Fern Bay Seaside Village Project Application

Further Response to Submission Report

Date:	7 April, 2010
Partner:	 Paul Douglass

Aspen Group

DRAWING TITLE SITE & STAGING PLAN REV-A
DEVELOPMENT PROJECT PLAN A FERN BAY SEASIDE VILLAGE NELSON BAY ROAD, FERN BAY
CLIENT ASPEN GROUP LIMITED

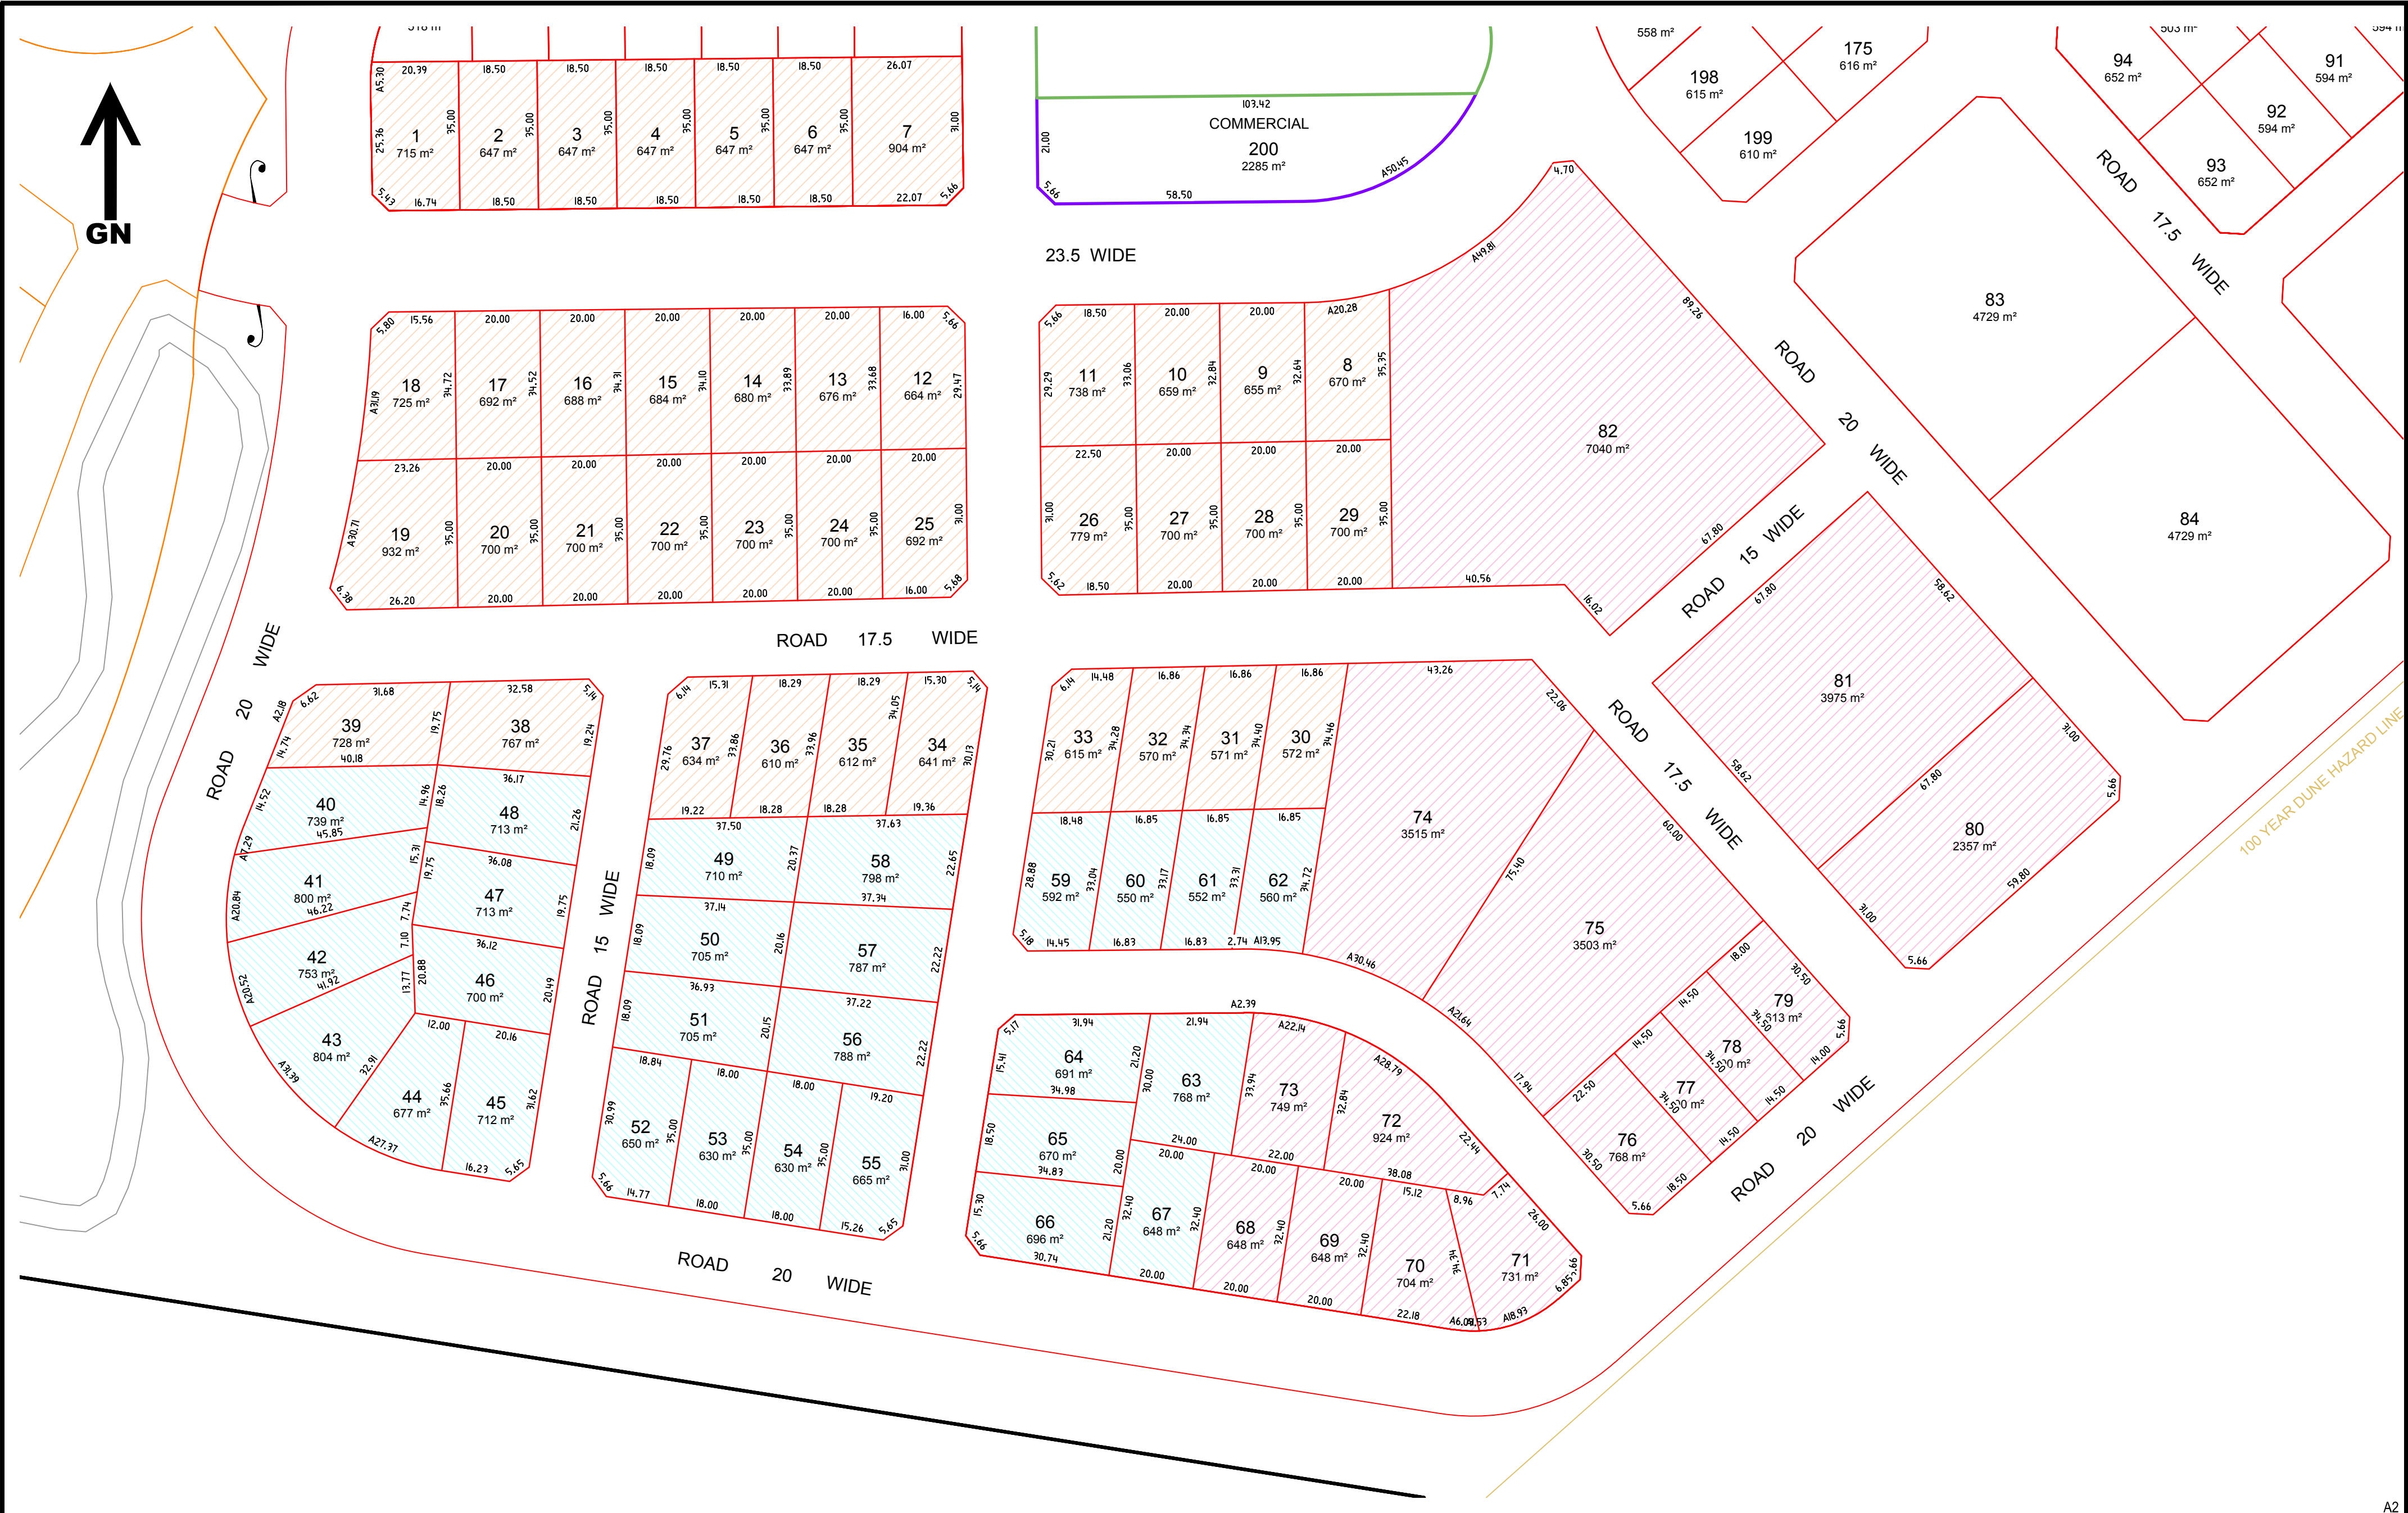
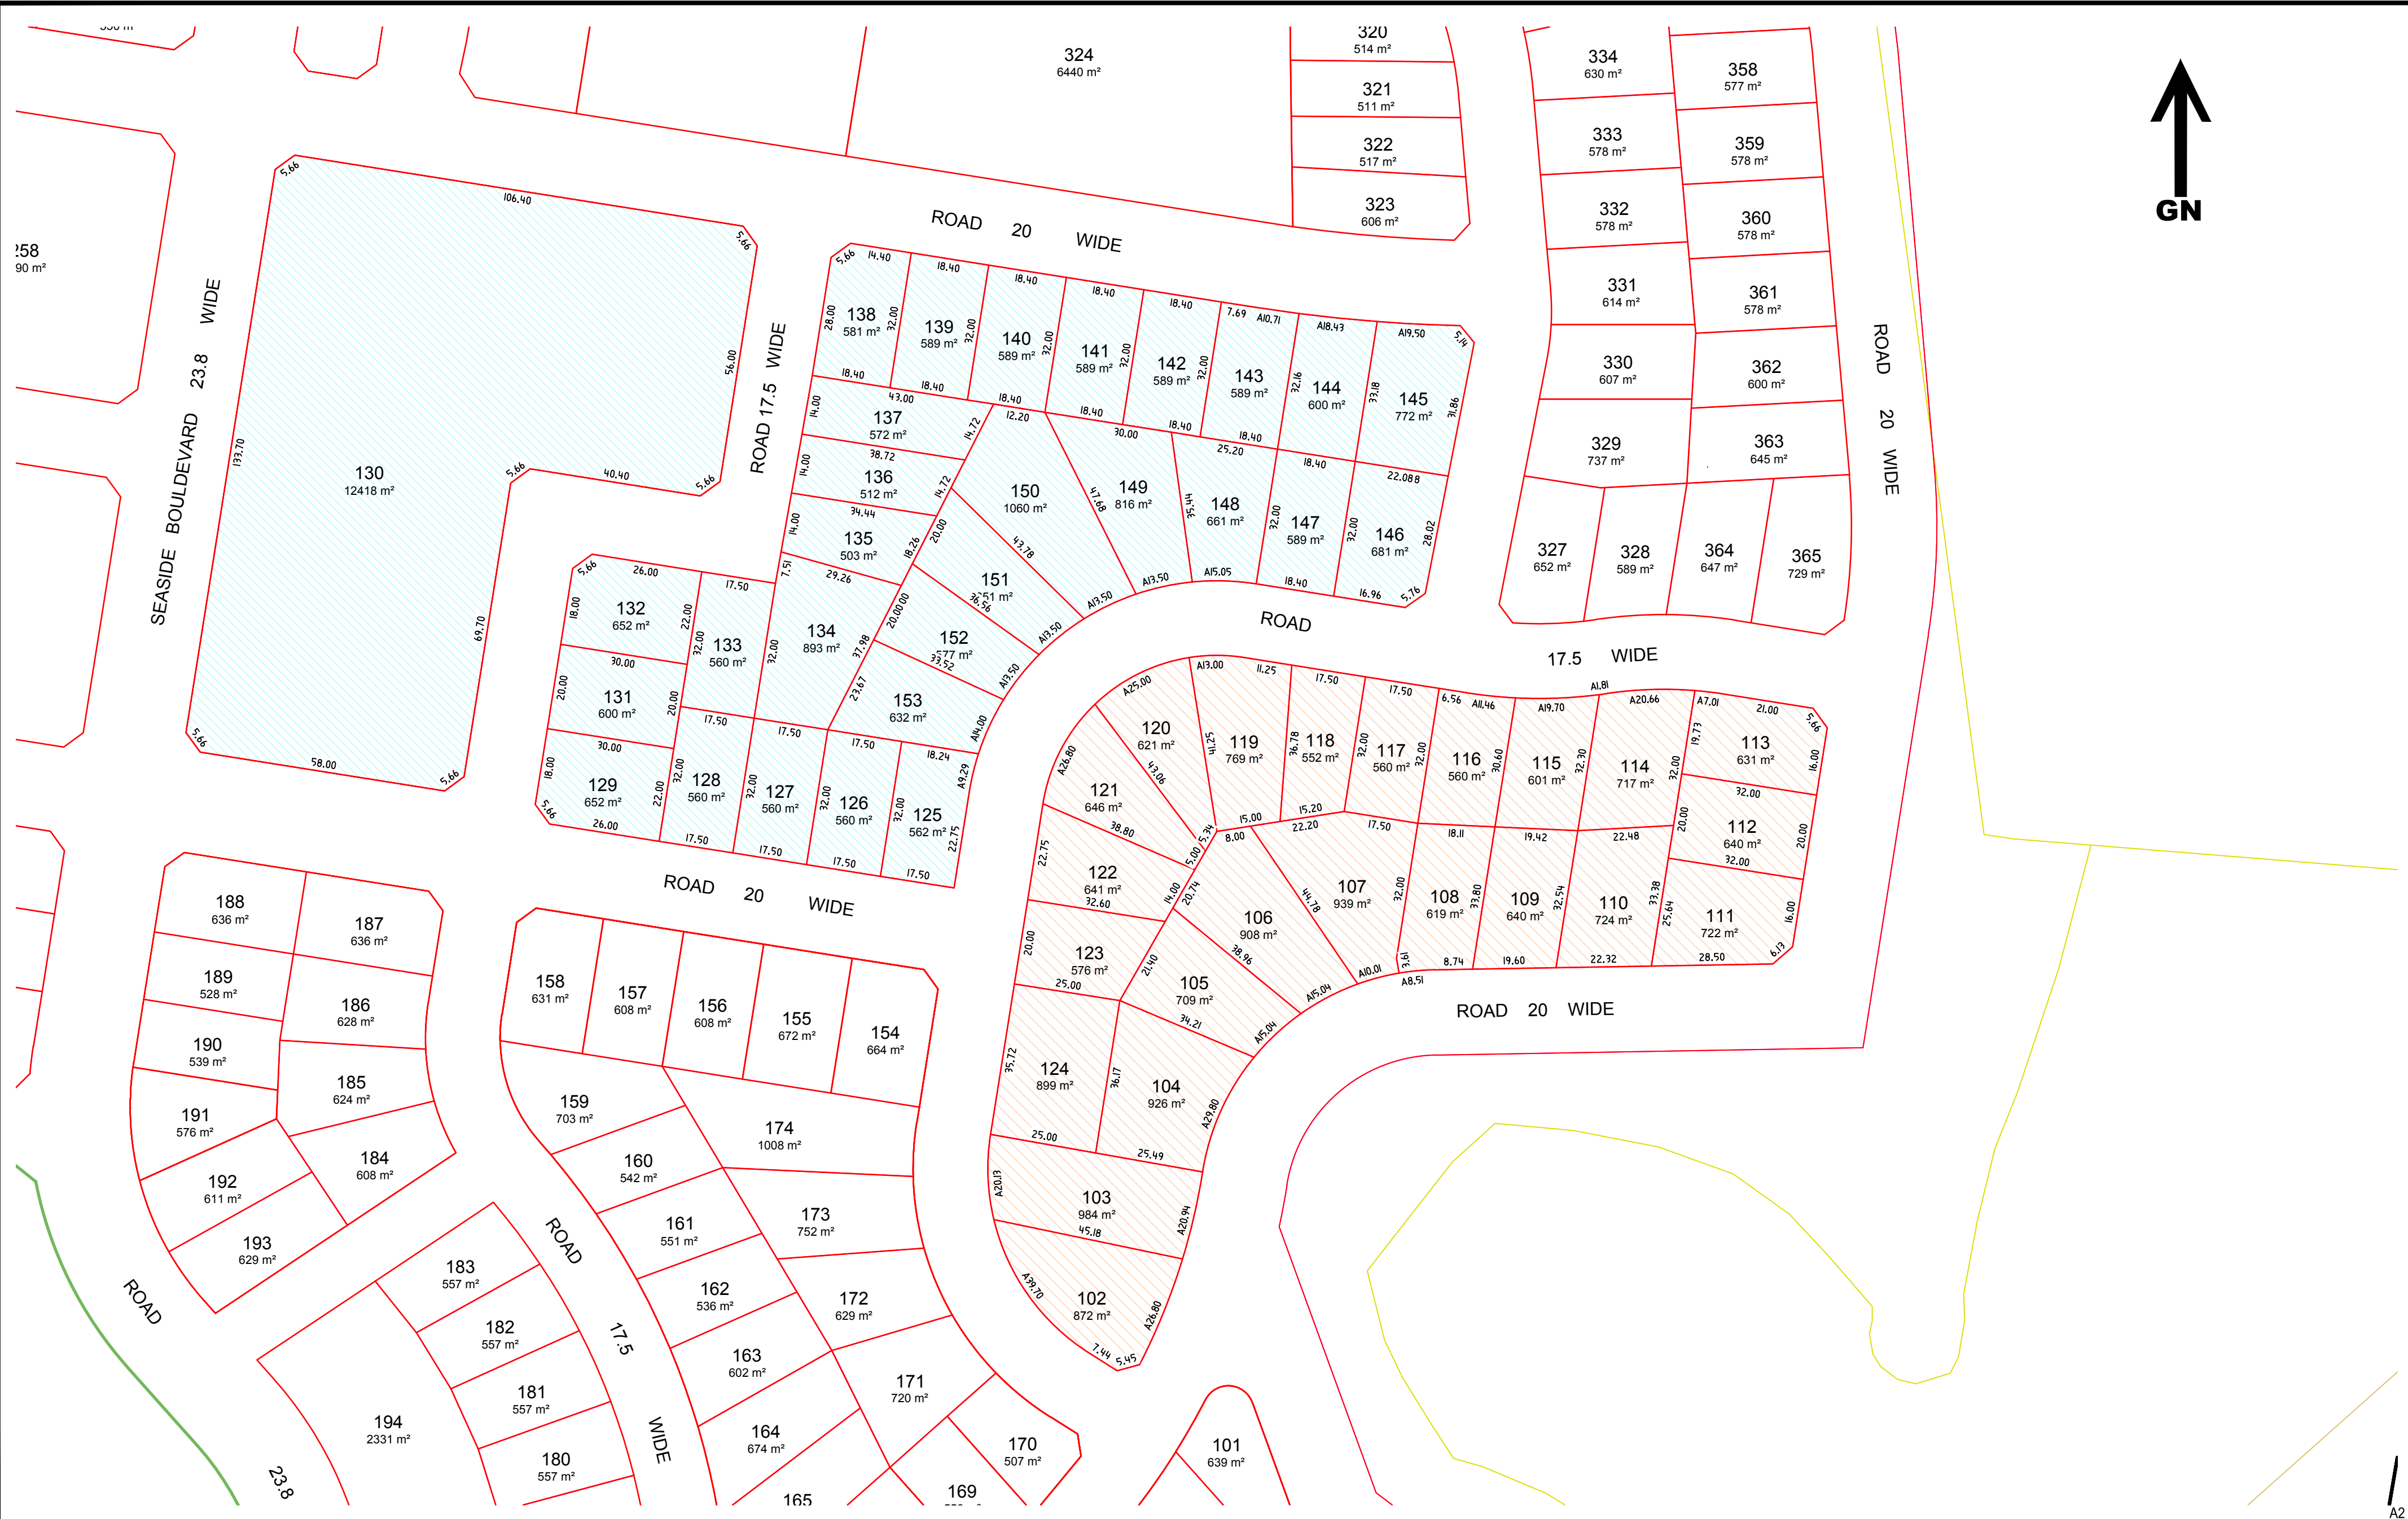
The Department of Planning has raised concern regarding compliance with the Port Stephens Development Control Plan (DCP) 2007. The Department is concerned with the overall connectivity within the estate and therefore requests that the length of street blocks and connecting pathways and the provision of bus stops be revisited taking into account the response received from Port Stephens Council dated 01 February 2010.

Authority	Issue Raised	Issue Ref	Submission	Response
Department of Planning	Subdivision layout and traffic	1	Port Stephens DCP 2007 requires a maximum street block length of 160 m (B1.C11). There are a number of proposed street blocks (within Stages 4,5,9 and 17) that do not comply and exceed the required street block length by up to 120m. The subdivision plan should be amended by reducing block lengths and providing additional connecting pathways (within Stages 4,5,9 and 17), which will assist in achieving compliance and also ensure pedestrian access/connectivity to open space and proposed bus stops are within 400m walking distance from any proposed lots. Please refer to submission from Port Stephens Council dated 01 February 2010, which provides suggested design amendments which could address this issue.	Subdivision plans have been amended to comply with Port Stephens DCP 2007 (see sheet 1 of 22 amended plan set 29850 A attached in <i>Annex B</i>).

To meet this commitment the subdivision plans have been amended to improve connectivity through Stages 4, 5, 9 and 17 as recommended (see Annex B).
